Independent Expert Panel for Mining in the Catchment Report: Part 1

Review of specific mining activities at the Metropolitan and
Dendrobium coal mines

14 October 2019

Figure 18: Extracts from presentation to the Panel by South32 showing predicted versus measured vertical surface displacement and closure in Area 3B based on the recalibrated prediction model

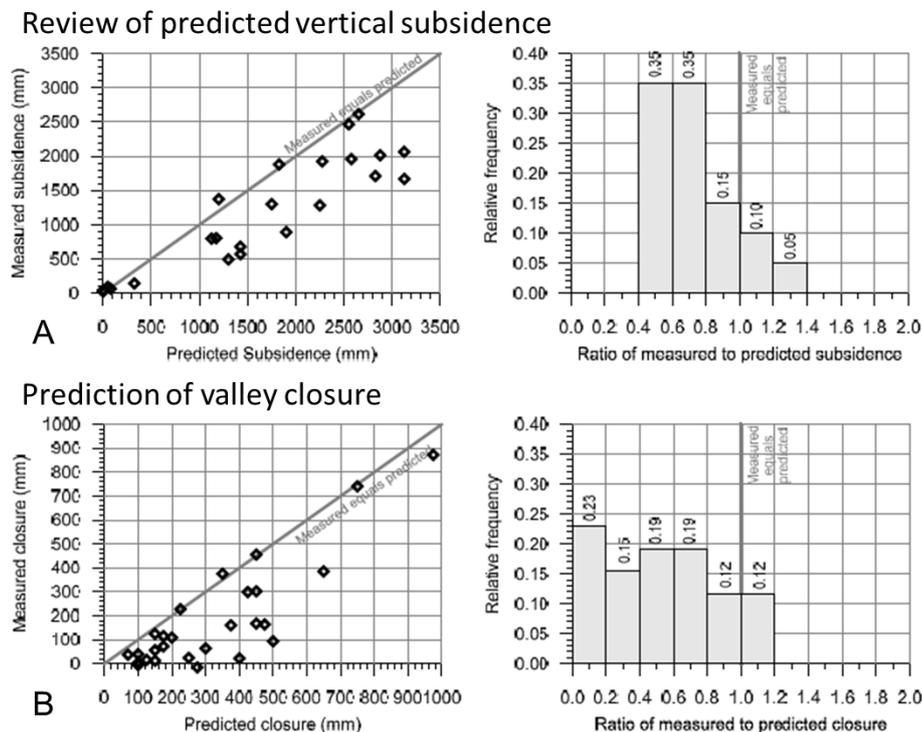
At a meeting between the Panel and South32 on 5 March 2018, the Panel was given a presentation on Dendrobium Mine that included the graphs shown in Figure 18 of predicted versus measured vertical surface displacements and valley closure over Area 3B. The Panel notes that the predictions of vertical subsidence are retrospective as they are based on the model that was recalibrated at the time LW 11 was being extracted.

The minimum excavation width-to-depth ratio, W/H, for LW 1 to LW 11 ranged from 0.6 to 0.98 and the maximum ranged from 0.86 to 1.56. Based on Figure 12, it could be expected that there are areas above most of these longwall panels that fell within the supercritical range and, therefore, would have experienced maximum possible vertical displacement. Field measurements generally confirm that this was the case. Figure 12 shows that maximum vertical surface displacement was approximately 78% of the mining height, which is at the high end for Australian coal mines.

Figure 23: Comparison between the maximum observed and maximum predicted total subsidence for LWs 3 to 26 at Metropolitan Mine
 Source: (Peabody, 2018a)

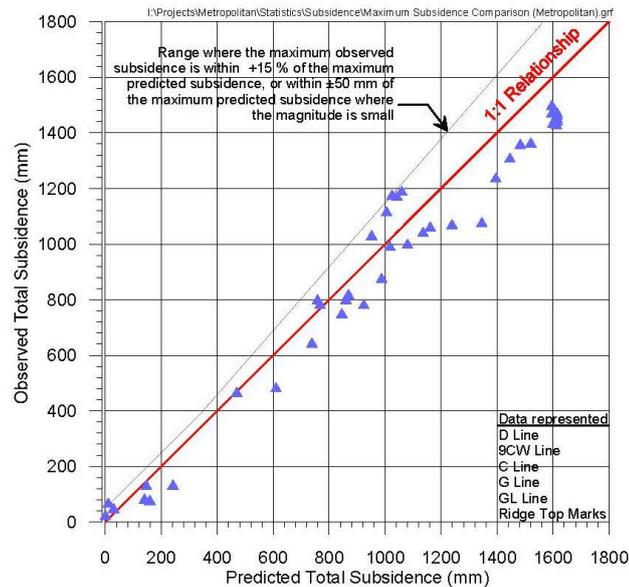
Figure 23, extracted from the Metropolitan Coal 2017 Annual Review (Peabody, 2018a), shows that measured total vertical displacement over LW 3 to LW 26 has not exceeded predictions by more than 15%. EOP reports indicate that vertical surface displacement profiles are also generally in accordance with predictions. The Panel concludes that subsidence effects have been reasonably well predicted.

Figure 24: Predicted closure profiles along the Eastern Tributary for the Preferred Mine Plan at the time of PAC assessment in 2009

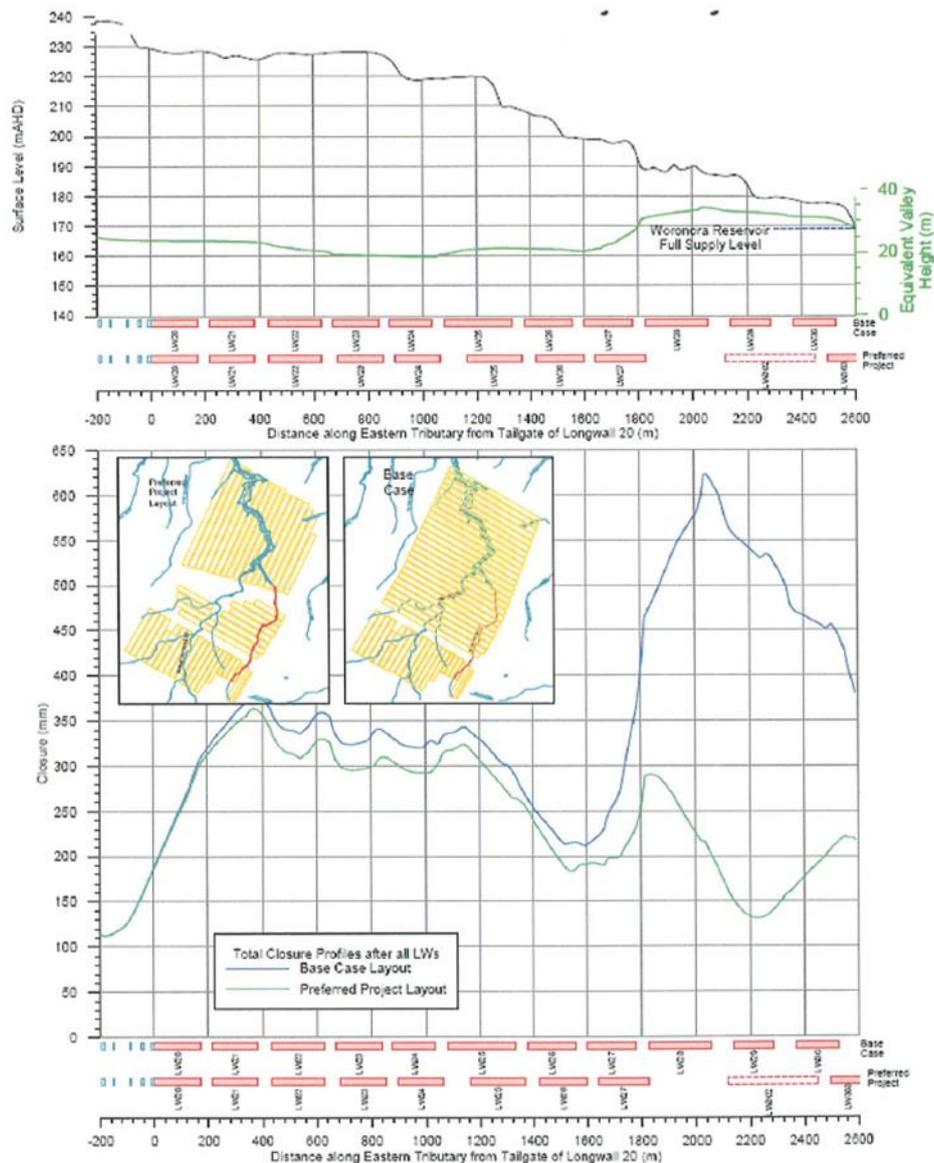
The Panel has had regard to the closure predictions shown in Figure 24 that were presented to the PAC and attached to the Conditions of Approval for the mine plan and to the performance measures set in the Conditions of Approval. Given the uncertainty associated with reliably predicting valley closure and its impacts, the Panel is of the view that the historic criteria of a maximum of 200 mm predicted closure for avoiding significant environmental consequences should be revised downwards, at least for watercourses.

Figure 29: Comparison between the height of complete drainage as predicted by the Tammetta equation (Tammetta, 2013) and the DGS geology equation (Ditton & Merrick, 2014) when applied to the database of DGS (2014)⁷⁴

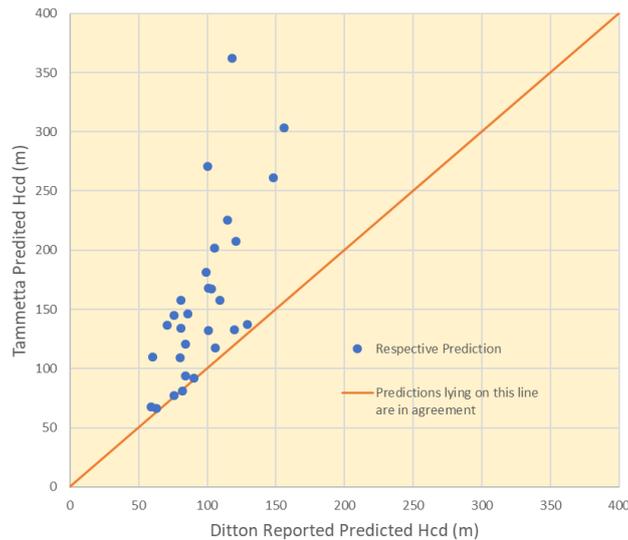
Figure 29 and Figure 30 highlight the nature of the problem, wherein the Tammetta equation (Tammetta, 2013) typically predicts a 40% to 60% greater height of complete drainage than the DGS geology equation (DGS, 2014; Ditton & Merrick, 2014). This has significant implications for Dendrobium Mine as illustrated by Figure 30A, because the Tammetta equation predicts complete drainage all the way to the surface over the centreline of longwall panels in Area 3B. In contrast, the mean height of complete drainage at Metropolitan Mine is predicted to remain about 300 m below the surface (Figure 30B).

Figure 30: Comparison between the predictions of the Tammetta equation (blue squares) and the DGS geology equation (orange diamonds) based on typical extraction height and depth of mining at Dendrobium and Metropolitan mines

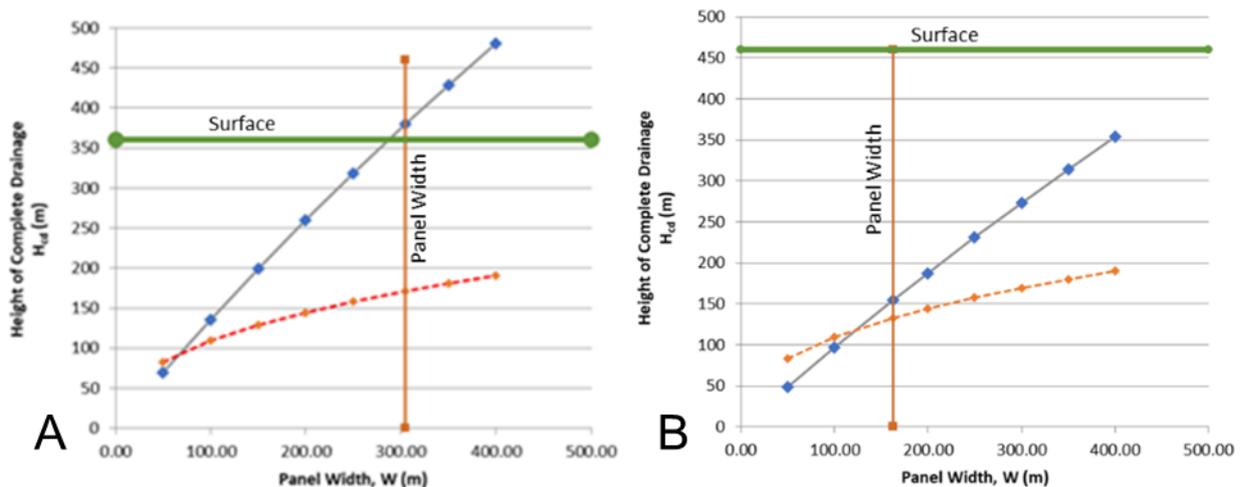
In respect of the Tammetta and DGS equations, Figure 30A shows that the Tammetta equation predicts that the height of complete drainage extends through to the surface over Area 3B at Dendrobium Mine. However, the PSM study concluded that groundwater *“response at Dendrobium has not exhibited full depressurisation at any height apart from the near-surface zone ... pore pressure profiles exhibit a gradual change in depth and do not exhibit the discontinuities as suggested by Tammetta (2013) and Ditton and Merrick (2014)”*.

Figure 33: The Tammetta and DGS databases shown as (A) extraction height plotted against effective panel width and (B) as depth of mining plotted against effective panel width, with the corresponding information also shown for Dendrobium Mine and Metropolitan Mine

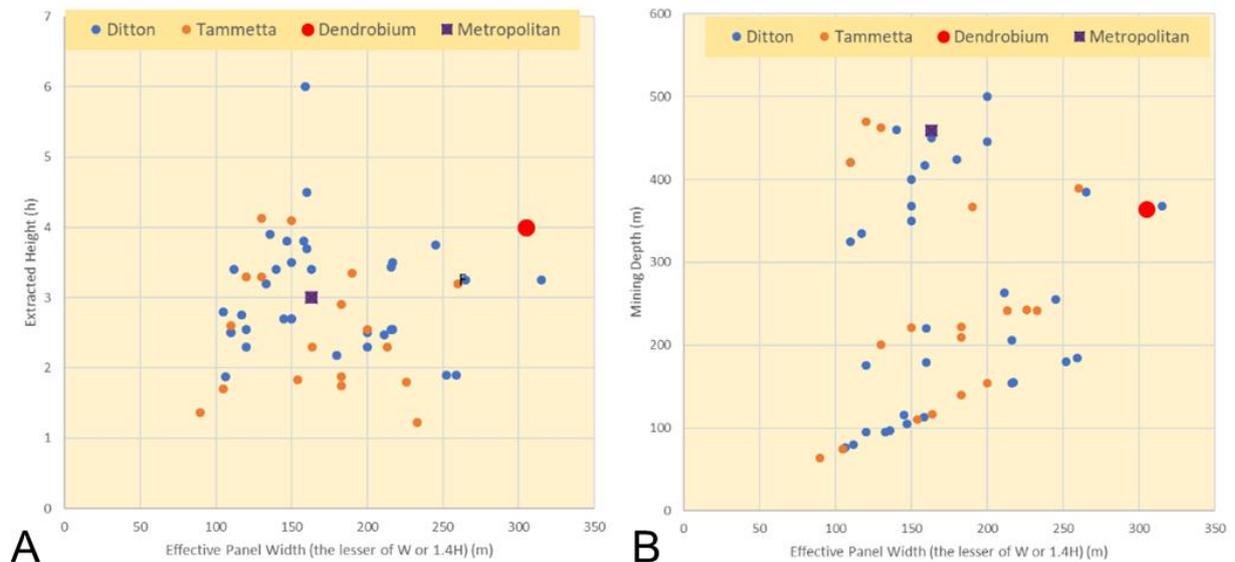
Figure 33 shows that the mining parameters associated with Metropolitan Mine are common to both databases (surrounding clusters). However, the parameters associated with Dendrobium Mine plot as an outlier with only one data point nearby which is Springvale Mine in the DGS database.⁷⁸ Significantly different subsidence outcomes are associated with these two data sets as illustrated in Figure 12.⁷⁹

⁷⁹ This is not the complete picture as the equations are based on sets of data, with each set comprising three parameters. The Panel has assessed this factor and formed a view that conclusions drawn from presenting the data in Figure 33 as sets of two instead of three parameters are reasonable.

Figure 34: The 2013 Tammetta and 2014 DGS databases plotted in terms of (A) effective panel width and (B) height of complete drainage per metre of extraction height

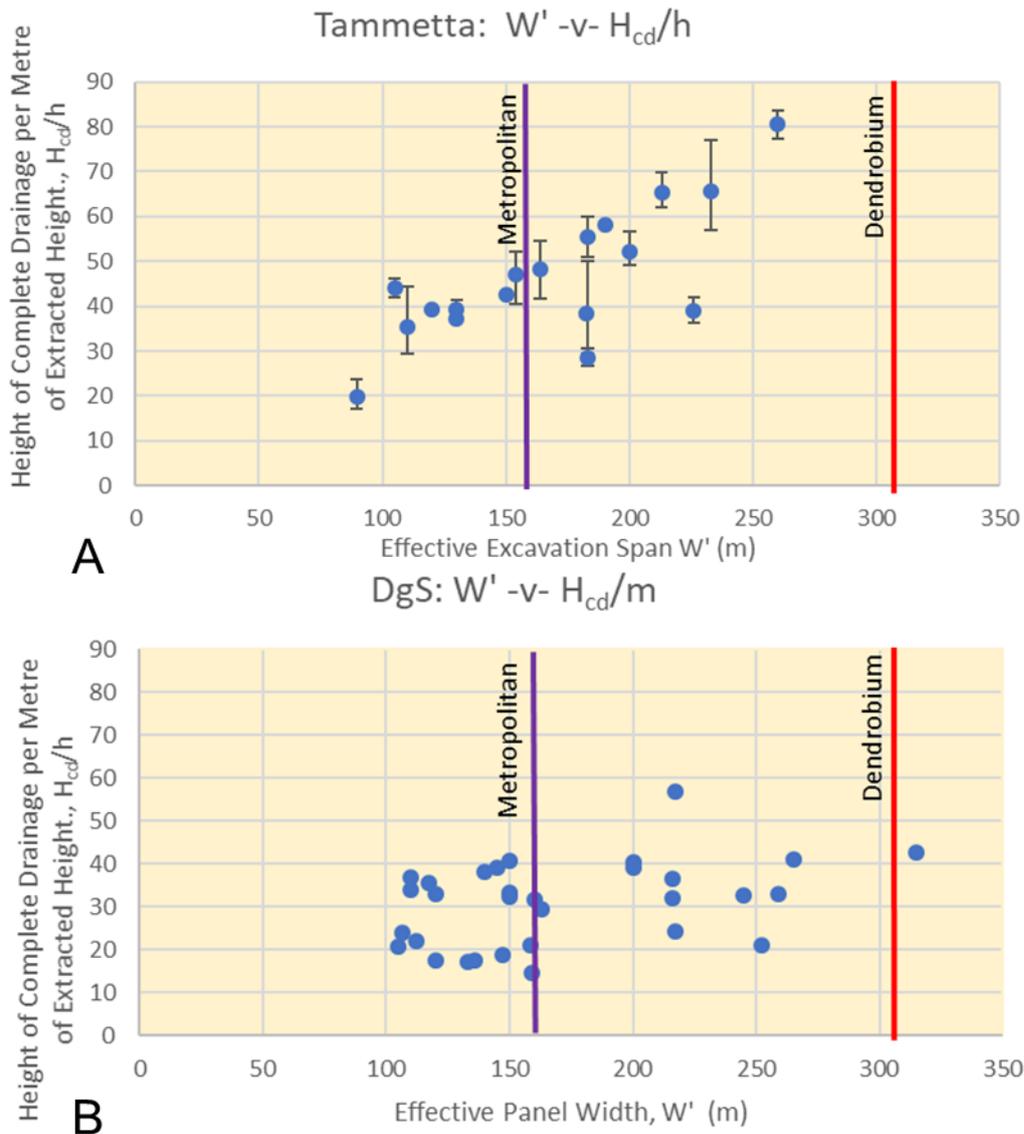
Figure 34 shows effective panel width plotted against height of free drainage normalised with respect to extraction height for each data point. The Tammetta data is characterised by the ratio of the height of complete drainage to extraction height exceeding 43 at 50 % (or 9) of the sites, compared to only at 3% (or 1) of the sites in the DGS database, and by a distinct increase in this ratio with increasing effective panel width, peaking at a value of 81. The DGS data is characterised by ratios in the range of 20 to 43 across a similar range of effective panel widths.

From a geotechnical perspective, the increase in normalised height of complete drainage with increasing panel span (Figure 34A) displayed by the Tammetta database is to be expected but it is remarkably uniform by geotechnical standards. Conversely, the range in the normalised height of complete drainage about a given panel span in the DGS database is to be expected but the relative insensitivity of this range to increasing excavation span is surprising (Figure 34B). Data scatter about a given panel width is an expected consequence of the uncertainty associated with estimating the height of complete drainage and the range of factors noted in Chapter 2 that influence rock mass response to mining.⁸¹ However, except for one data point (where it is known that the A-Zone interacted with the surface), the range in height of complete drainage in the DGS database changes very little as panel width is increased, with the maximum height of complete drainage relatively fixed at approximately 40 m per metre of extraction height.

Figure 35: Comparison between measured height of free drainage for the same sites in the databases of Tammetta (2013) (orange), and DGS (2014) measured to top of 'A-Zone' (blue)
Data source: Tammetta (2013) and DGS (2014)

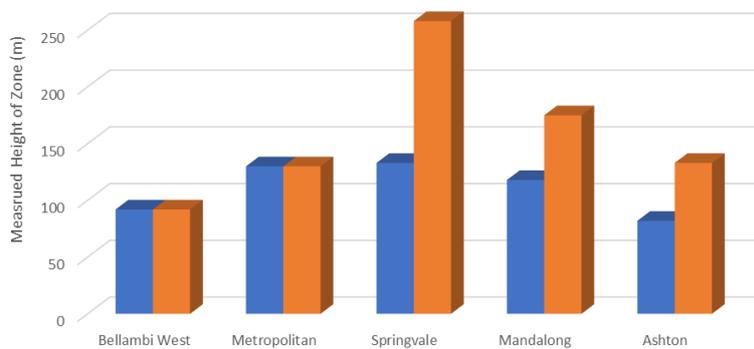
The values associated with the five sites common to both data sets have been plotted in Figure 35. Two sites are in agreement. In a review prepared for the owner of two⁸⁰ of the remaining three sites, Seedsman Geotechnics (2014) reported that it is not clear how Tammetta derived values from incomplete data sets at these sites.

Figure 37: Comparison based on the DGS database between predictions of height of complete drainage calculated with the DGS geometry equation (blue) and the DGS geology model with t' set to 1 m (orange).

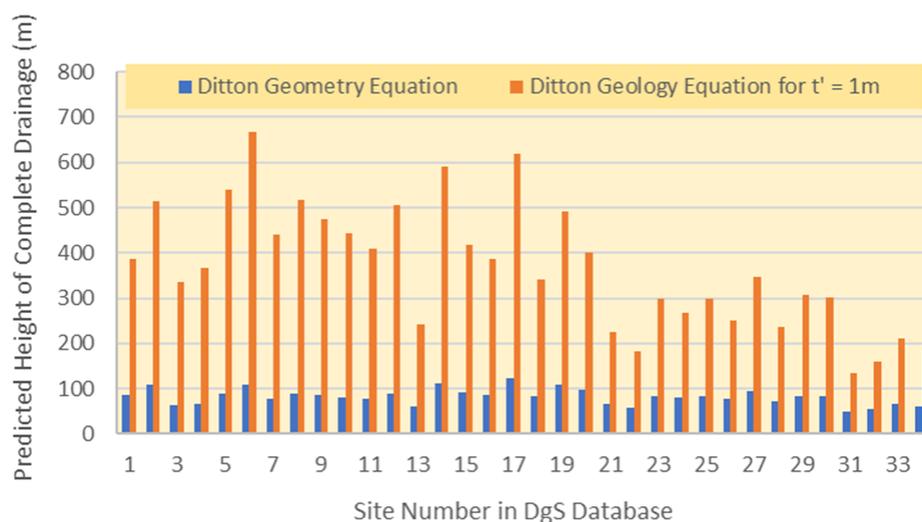
The Panel has investigated this aspect based on the logic that if mechanistically sound, the DGS geology equation and the DGS geometry equation should give similar predictions when no thick strata units are present since both equations were calibrated to the same database. Accordingly, working backwards, the predictions of the geometry model were compared to the predictions of the geology model with t' set to 1 m⁹⁷ for the DGS database to produce (as is to be expected), the significant differences in outcomes shown in Figure 37.

The application of an appropriate t' parameter in the geology model reduces this disparity so that the two equations predict similar outcomes. Therefore, the Panel next plotted the t' value assigned to each site in the DGS database against its panel width-to-depth ratio. The results, shown in Figure 38, reveal that except for one site, the selected t' values hover around 20 m for sites where the panel width-to-depth ratio is greater than 1. They vary from about 20 m to 35 m for sites in the range $\approx 0.6 \leq W/H \leq 1$, and from 30 m to more than 100 m for panels where $W/H \leq \approx 0.6$. The single exception is the only Dendrobium site in the database, where t' is significantly greater than all other sites with a width-to-height ratio $W/H \geq \approx 0.6$.⁹⁸
